WATERWHEEL BOOSTER STATION

SAWS Job No. 20-6008

ADDENDUM NO. 3

March 4, 2021

SHEET NO. **E5**

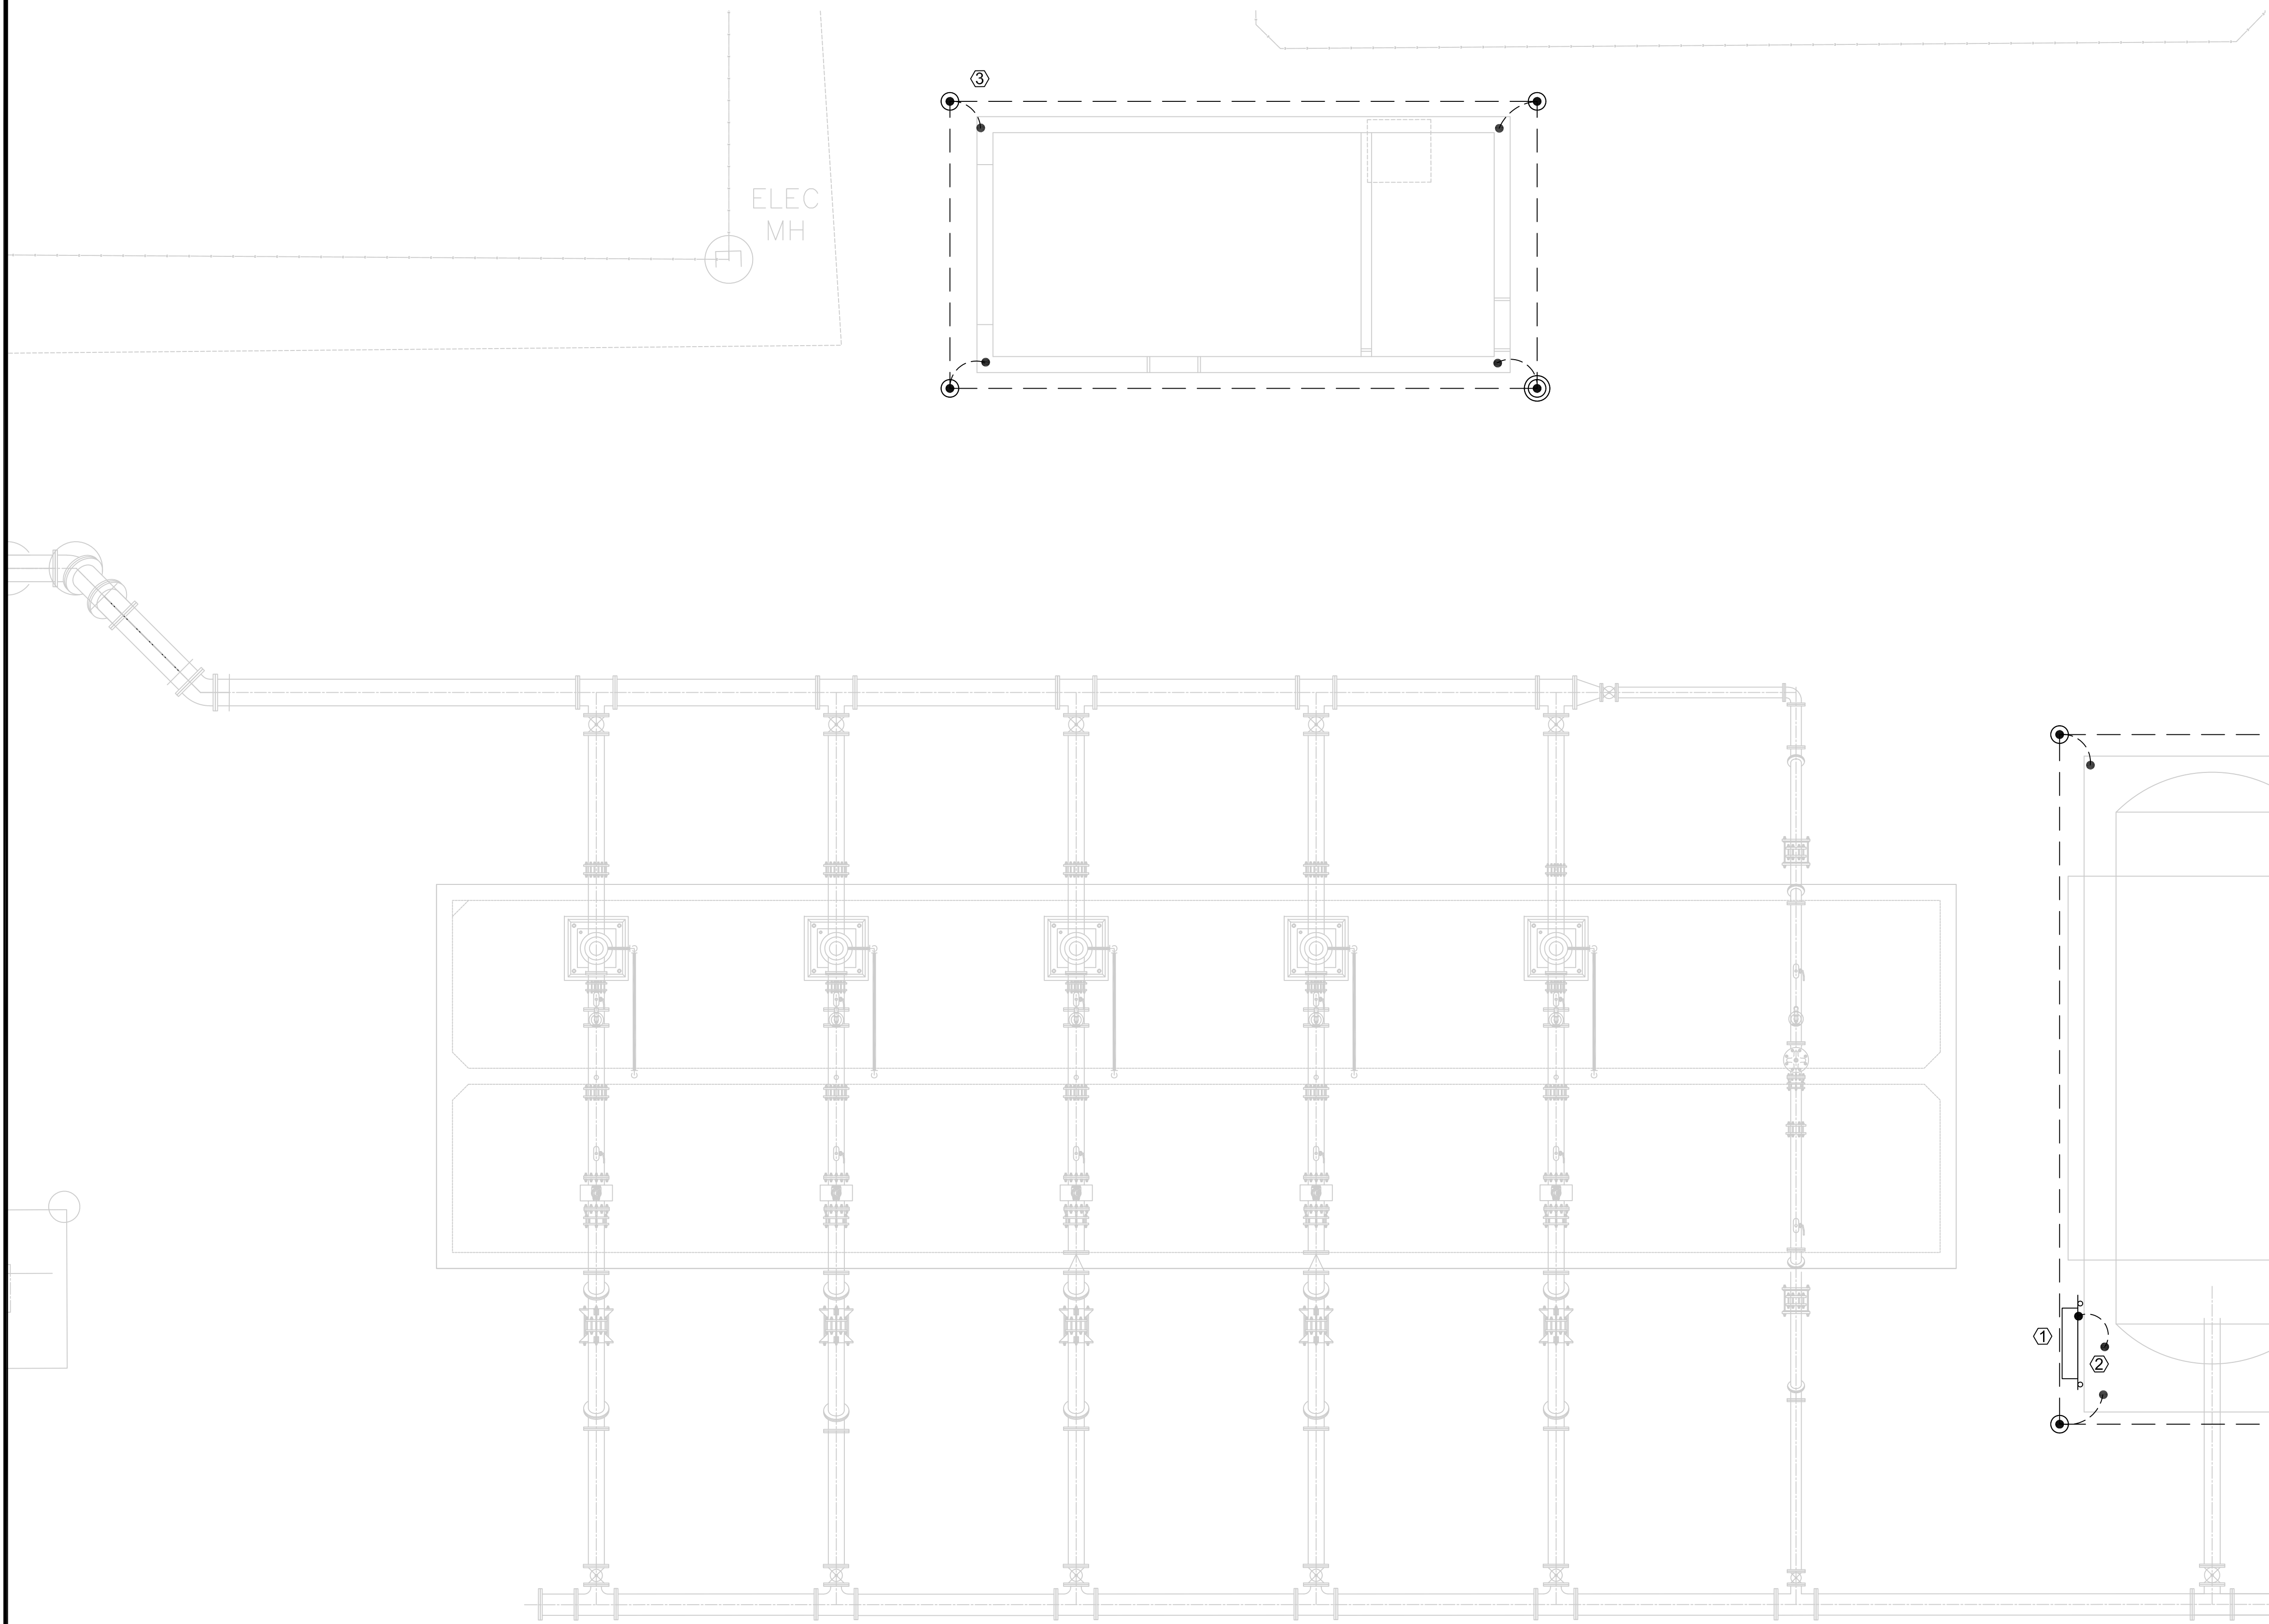
QUESTION 1: Please confirm drawing scale on Sheets E4, E5, and E6. This scale implies the pump pad is approximately 12' in width, while Civil drawings show the width to be 95'.

RESPONSE: The civil drawings are correct. Sheets E4, E5, and E6 have been revised to correct the scale, see "Changes to the Plans" number 1.

1. Remove and replace sheets E4, E5, and E6, which have been revised to correct the scale.
2. Remove and replace sheets E2 and E24, which have been revised to show the correct feeder conduit and cable.

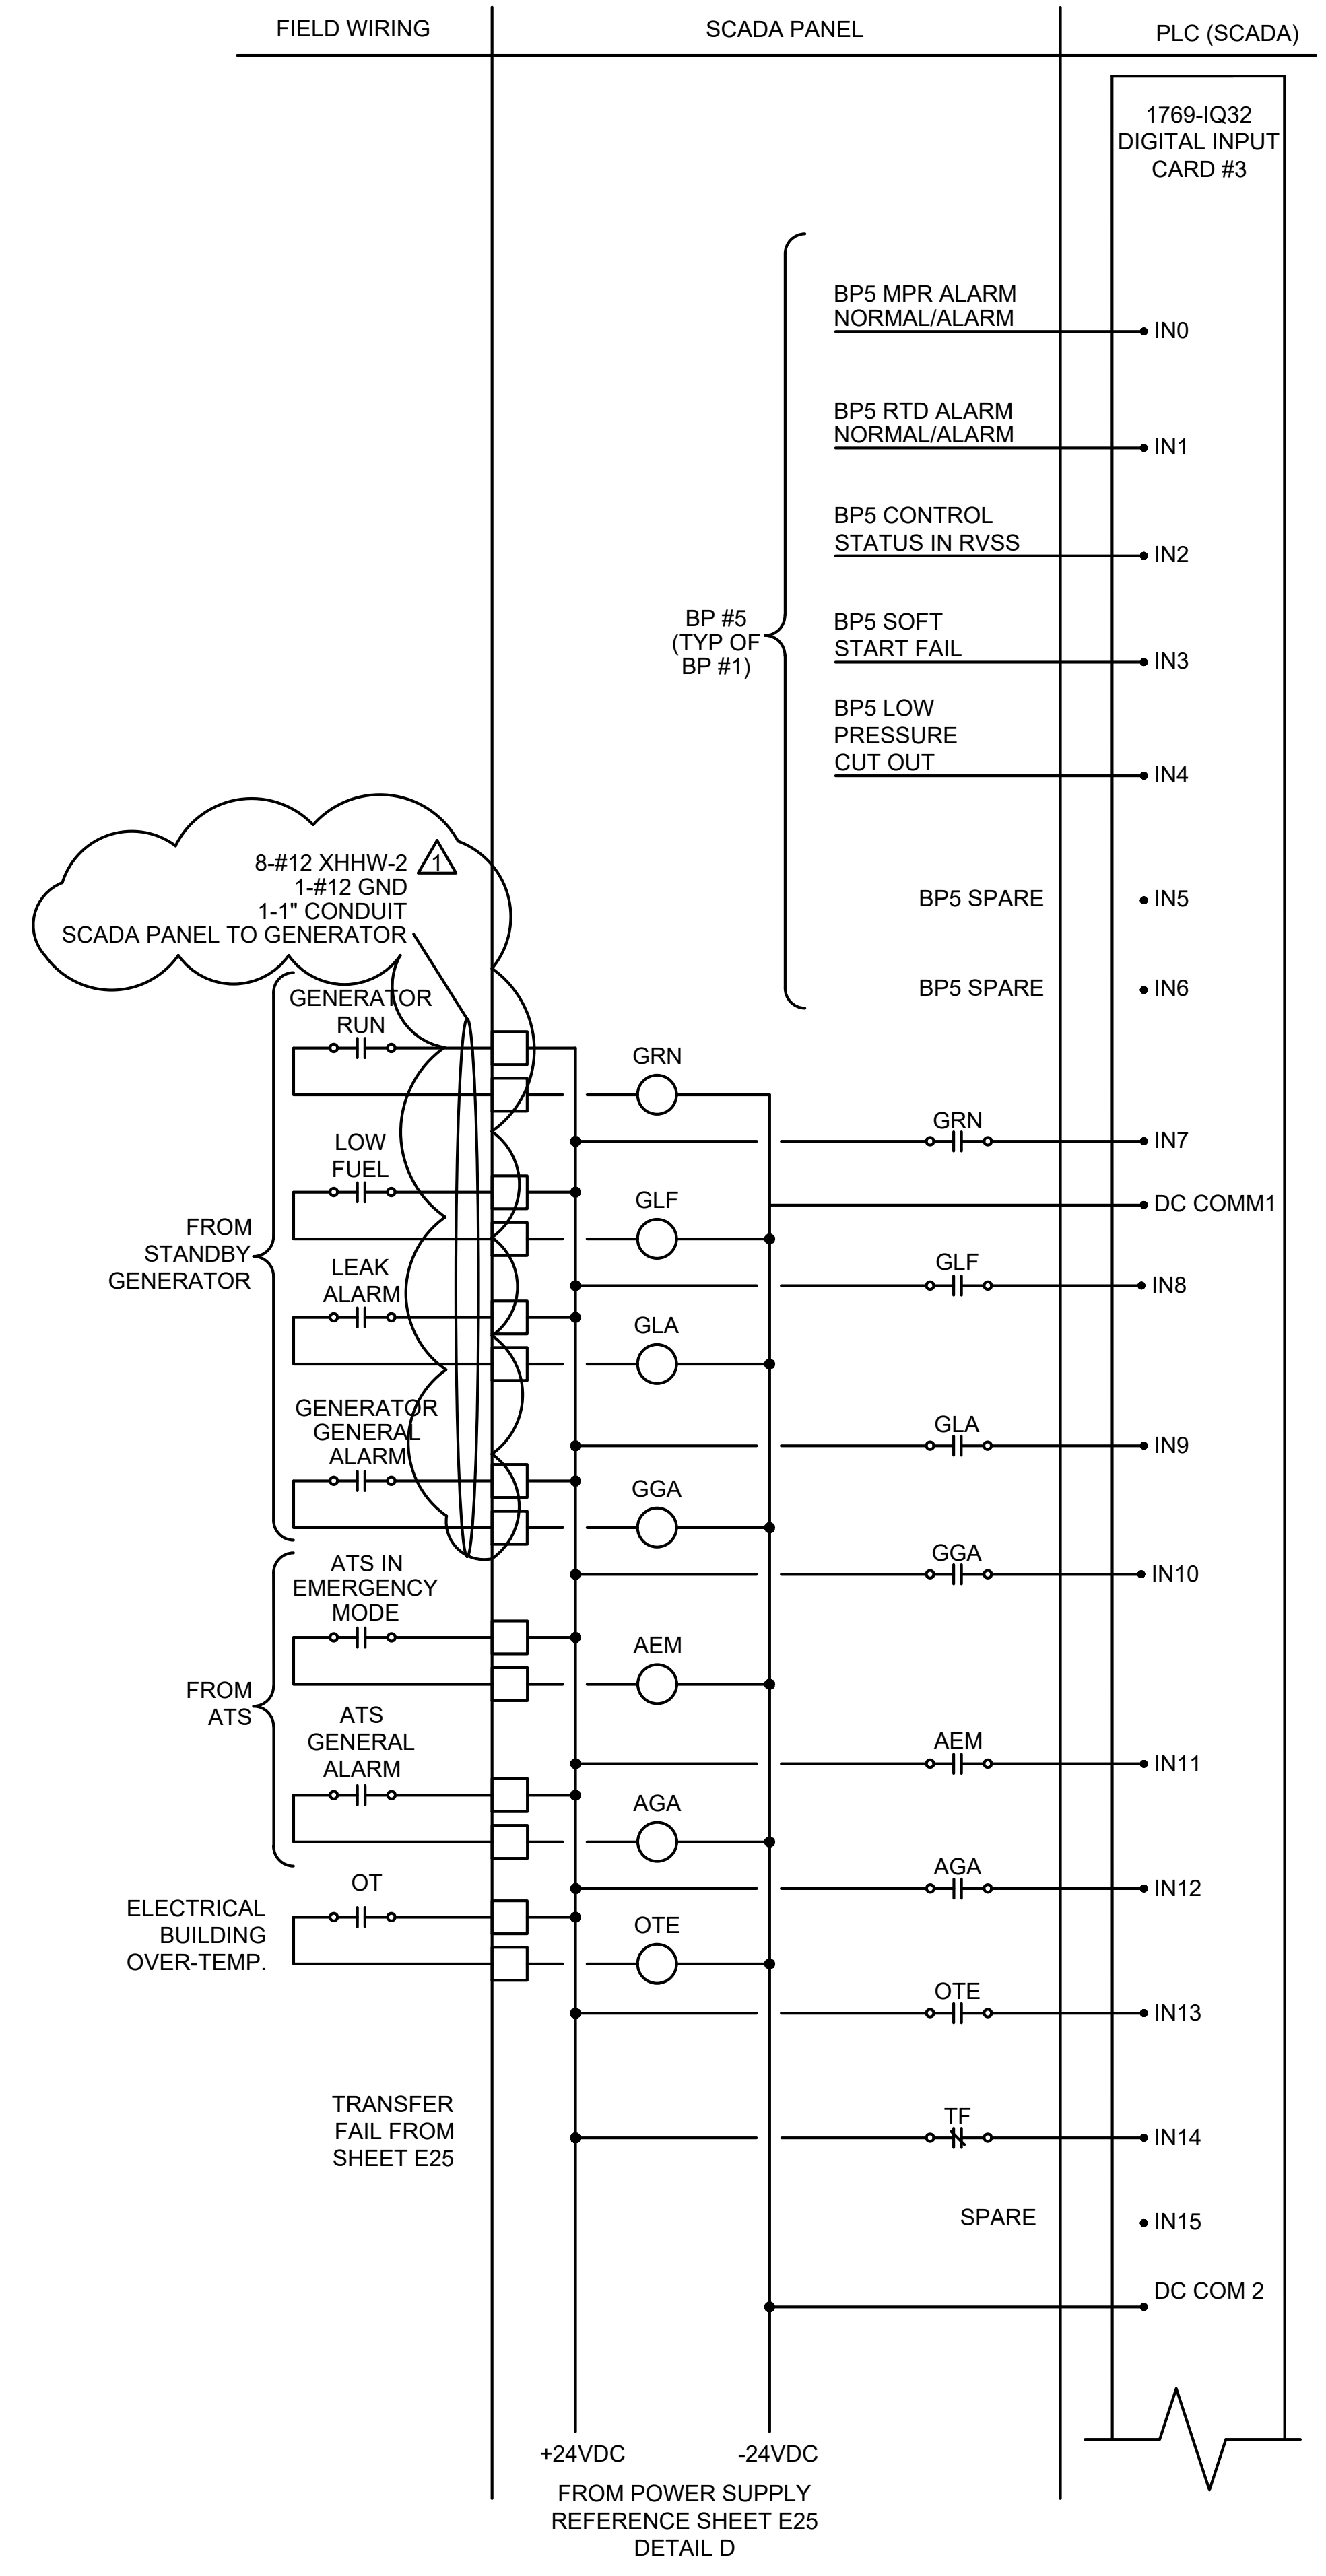
QUESTION 3: Please confirm a duct bank is to be run from new Control Building to Generator Slab. Provide any additional conduits or circuits that are required in addition to generator feeder to Bypass/Isolation Switch.

RESPONSE: It is confirmed that the duct bank is to be run from the new control building's bypass/isolation switch to the generator. See attached, revised sheet E2 for revised conduits and cables bypass/isolation switch and ATS is one unit. See attached, revised sheets E2 and E24 for any additional conduits/cables that are required in addition to the generator feeder to bypass/isolation switch.
